ADDENDUM #1
AVENUE OF THE OAKS REALIGNMENT
BID # 21/22-005 / PWP # WA-2022-084
BIDS DUE NO LATER THAN: 1:45 PM ON DECEMBER 16, 2021
PUBLIC BID OPENING: 2:00 PM ON DECEMBER 16, 2021

- 6) **Plan Sheet Revisions** – Four (4) revised plan sheets are included in this addendum.

AVENUE OF THE OAKS REALIGNMENT
Bid#21/22-005 PWP#WA-2022-084
Tuesday, December 7, 2021, 1:00 P.M.
Pre-Bid Meeting - Notes

CIVIL IMPROVEMENT PLANS FOR
AVENUE OF THE OAKS REALIGNMENT
SITE PLAN - WEST
CITY OF SPARKS, NEVADA

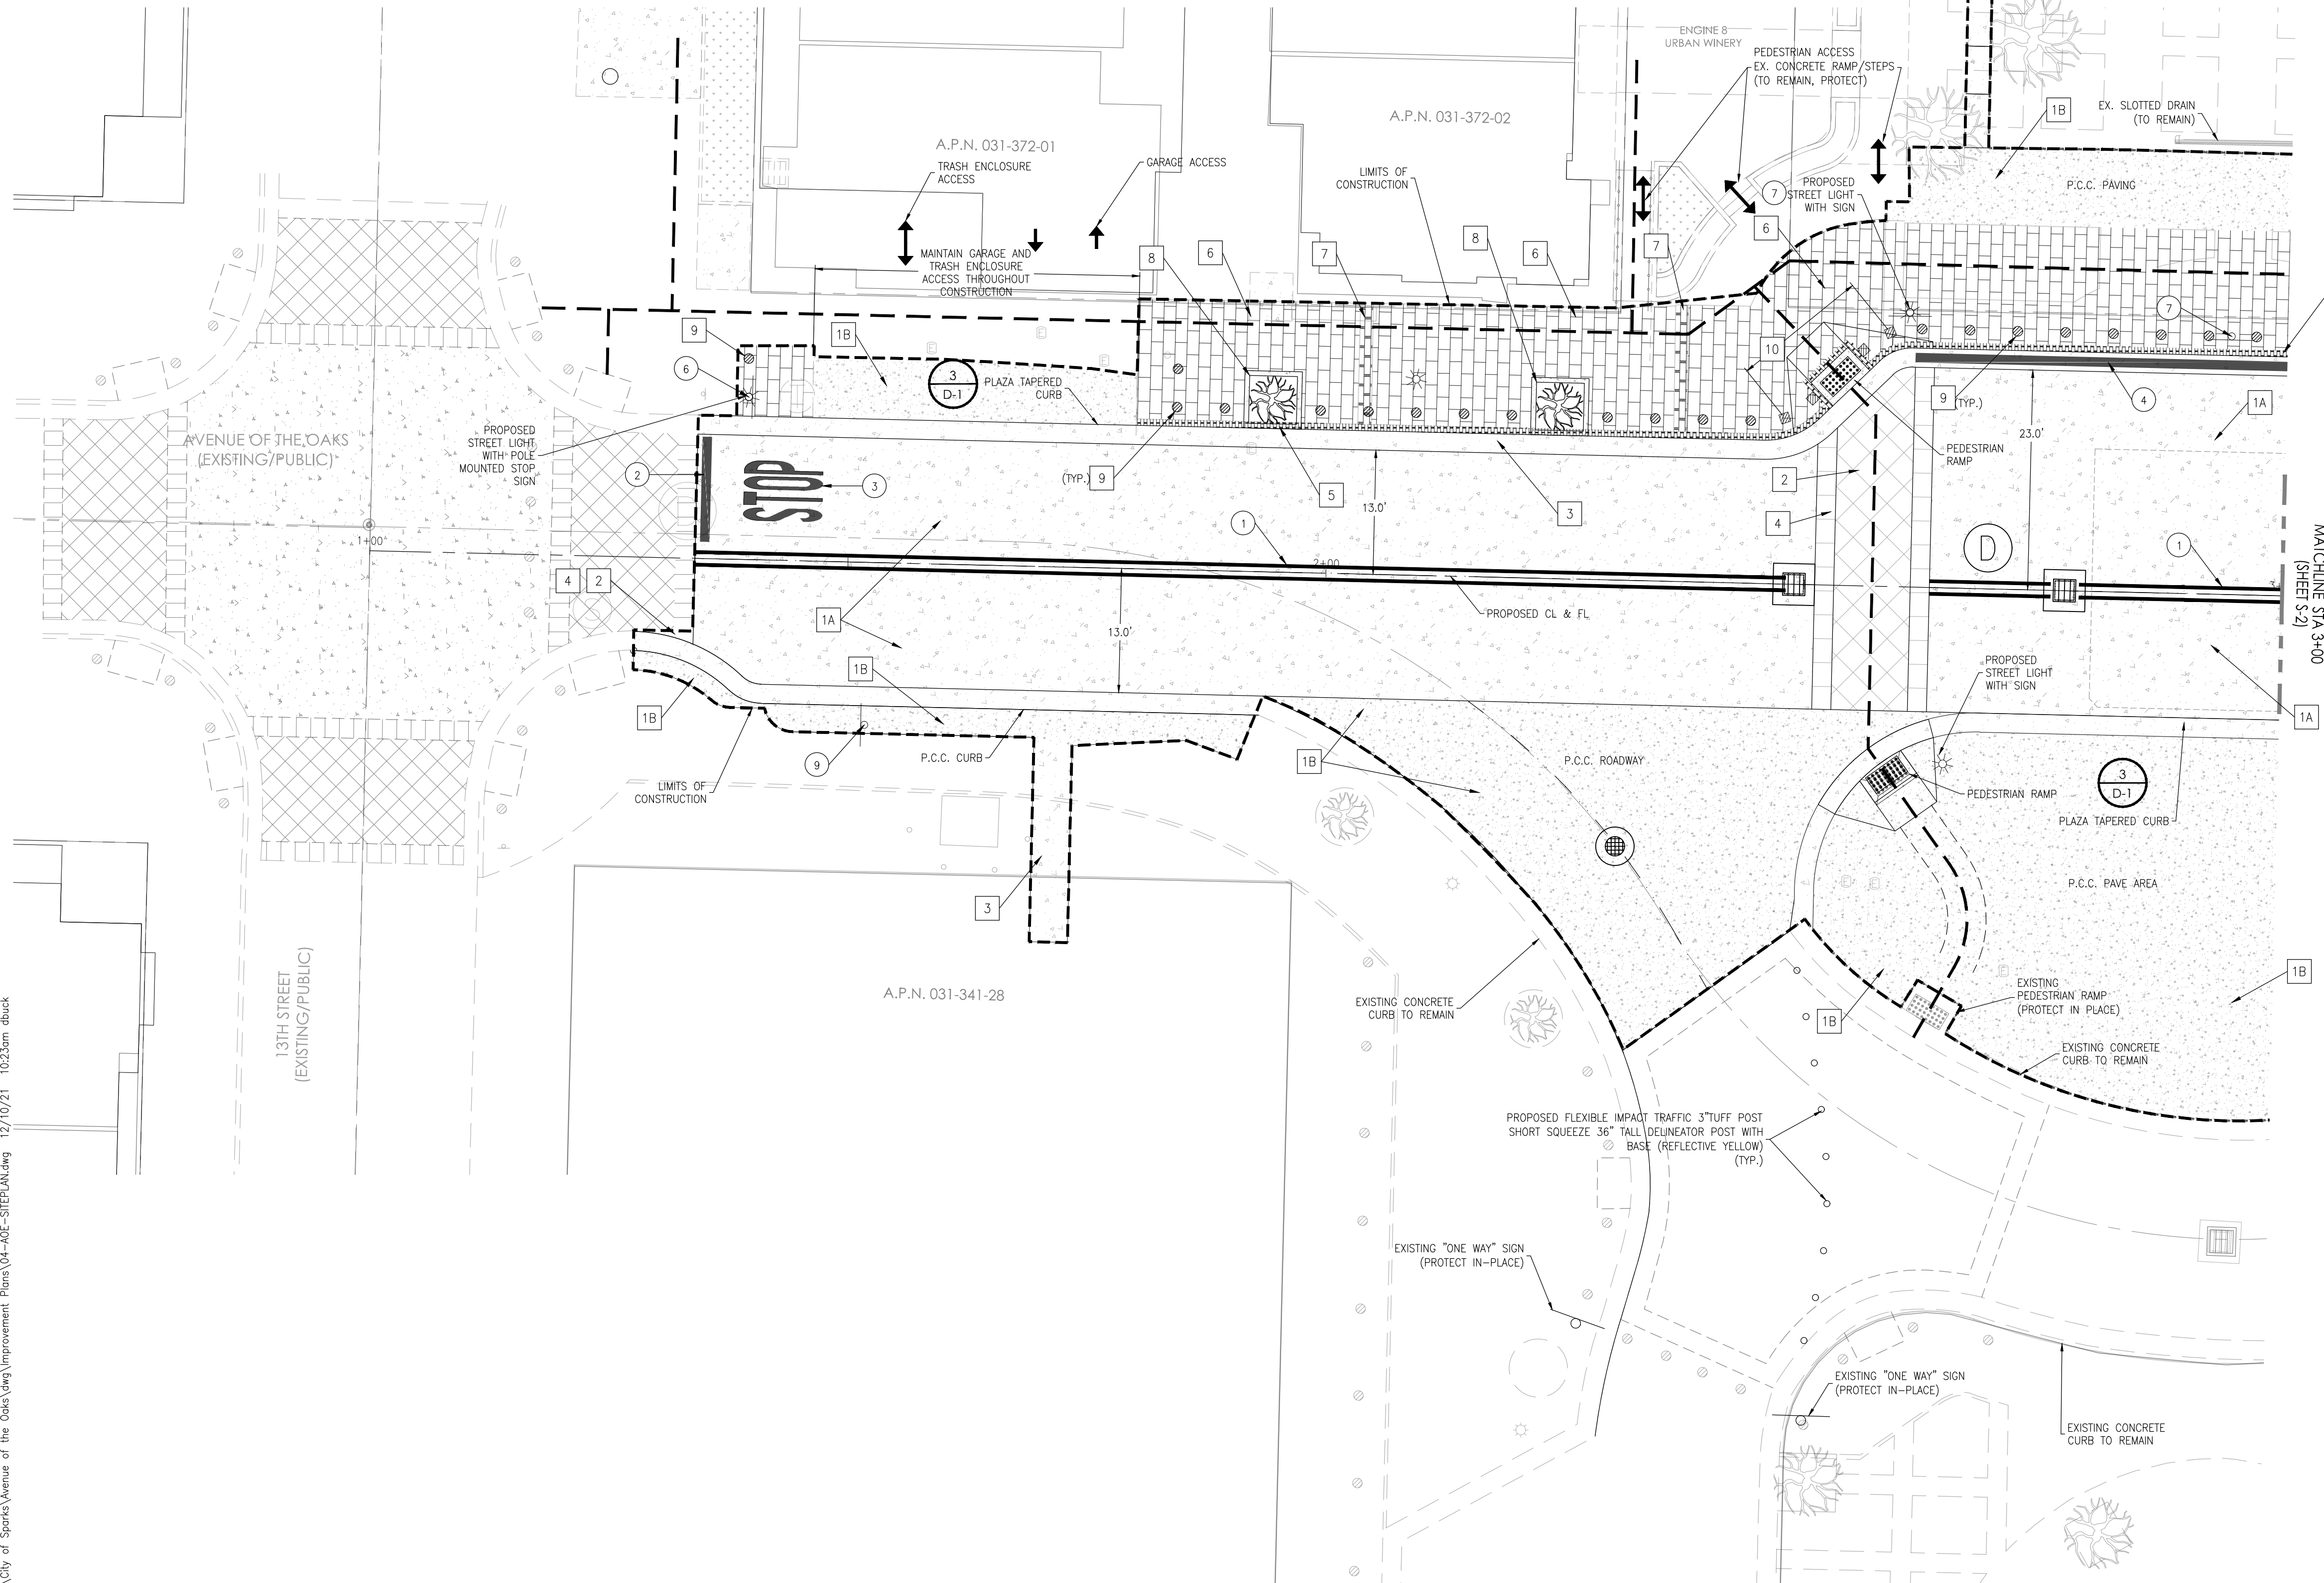
- P.C.C. ROADWAY SECTION SHALL BE 8" THICKNESS P.C.C. DOWELED PAVEMENT.
 - P.C.C. PAVET AREAS SHALL BE 6" THICKNESS P.C.C. SECTION WITH PLAIN JOINTS.
- PROVIDE JOINTING PER PLAN AND DETAILS.

CIVIL IMPROVEMENT PLANS FOR AVENUE OF THE OAKS REALIGNMENT SITE PLAN - EAST
CITY OF SPARKS, NEVADA

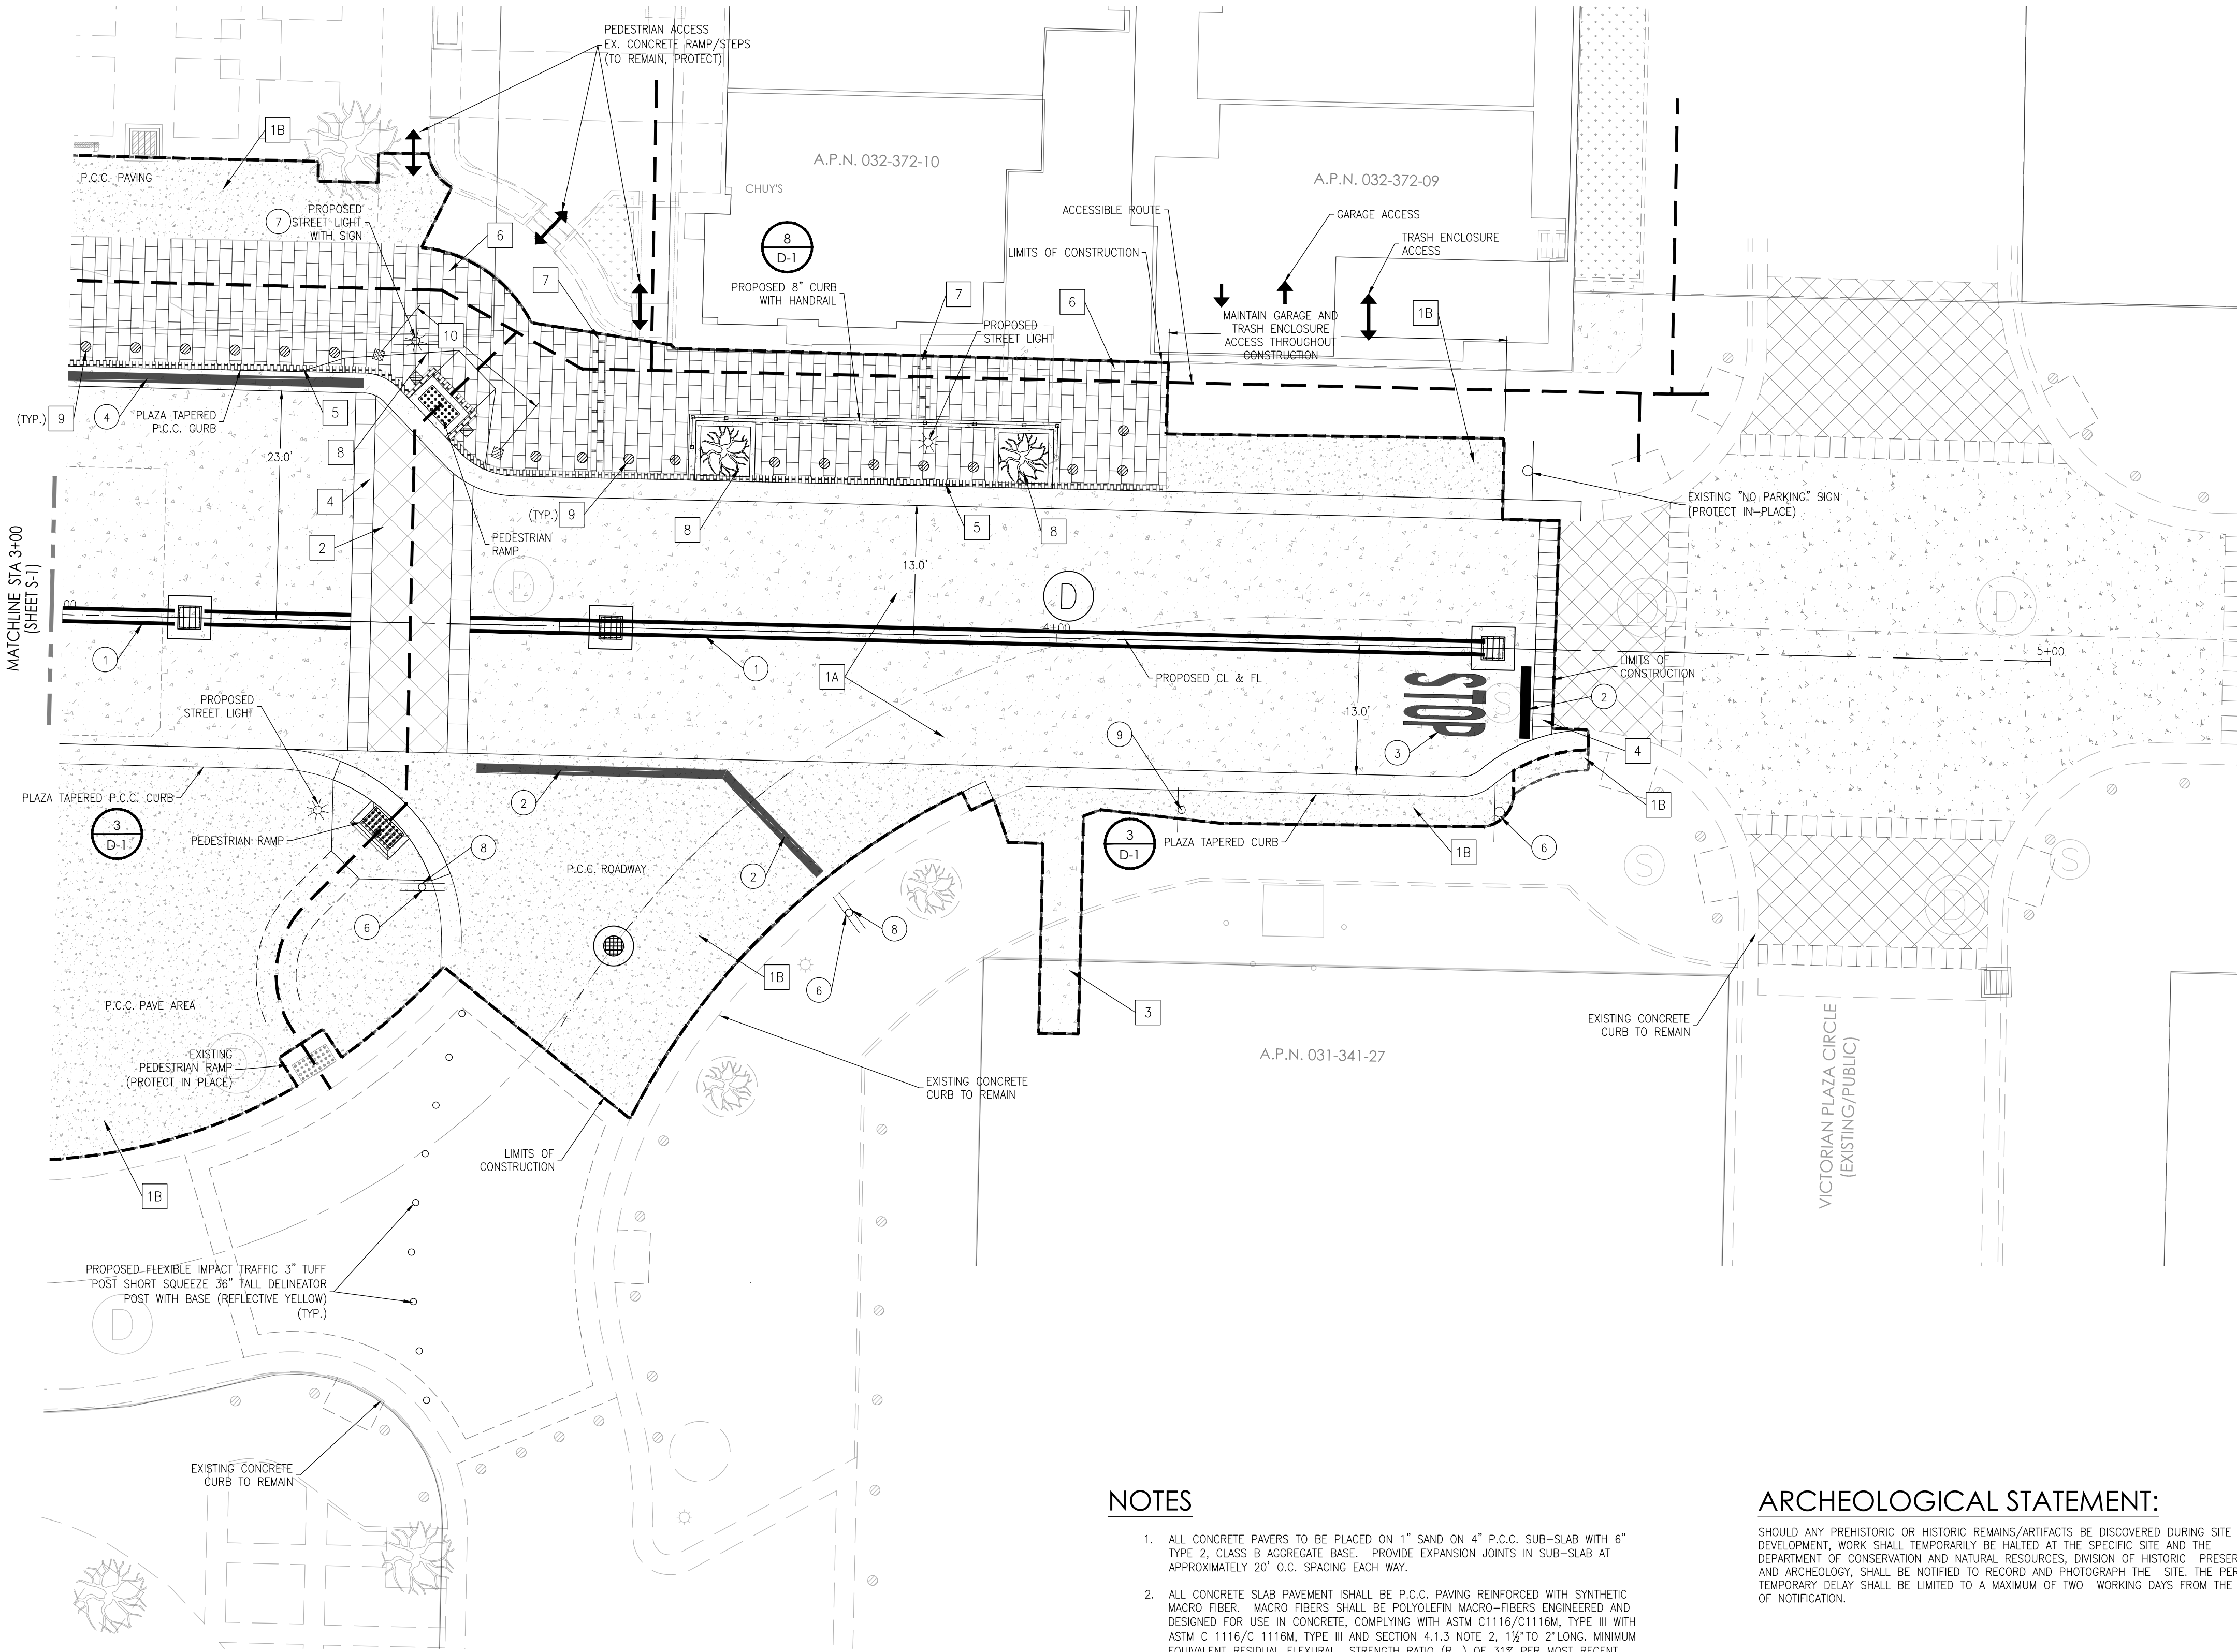
- 6 INSTALL "STOP" SIGN (R1-1) 
- 7 INSTALL "NO PARKING LOADING ZONE" SIGN (R7-6) (MAY BE LIGHT MOUNTED) 
- 8 INSTALL "DO NOT ENTER" SIGN (R5-1) 
- 9 INSTALL "NO PARKING ANY TIME" SIGN (R7-1)

Response – There are a total of nine (9) signs for the project: (Bid Schedule has been revised to show the revised quantity)
(2 EA) Install Stop Sign and Do Not Enter Sign (single pole installation), complete and in place.
(7 EA) Install Traffic Control Sign, complete and in place.
Bid 9 items with 11 total signs. Stop Sign and Do Not Enter sign are bid together as one item.
Individual sign count:

TYPICAL P.C.C. PAVEMENT SECTIONS NTS

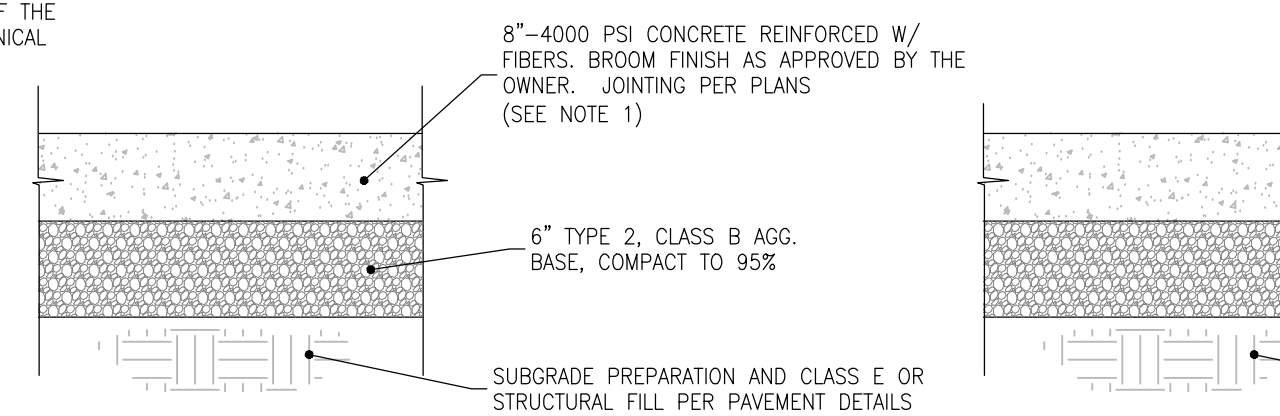
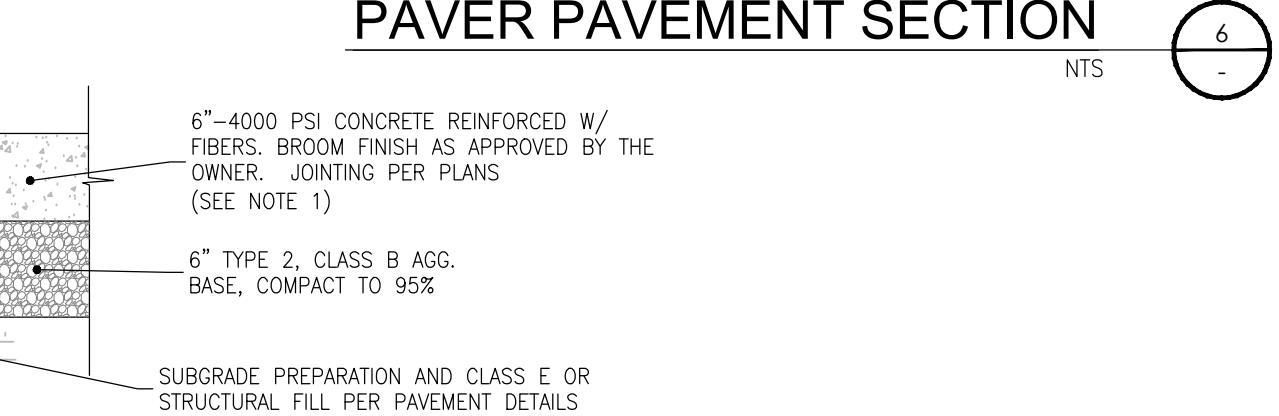
- i. Dowels with dowel baskets will be required in the Decorative crosswalk and the PCC Roadway. Dowels will not be required in the PCC Pave Areas.
 1. Decorative Concrete Crosswalk and PCC Roadway thickness may be increased to 8-inches. Will be covered in an addendum. If this happens – Bid Item 37 will become two (2) bid items to address the difference in the item thickness and dowel requirements.

**P.C.C. ROADWAY SECTION:
8\"/>**

**P.C.C. PAVE SECTION:
6\"/>**
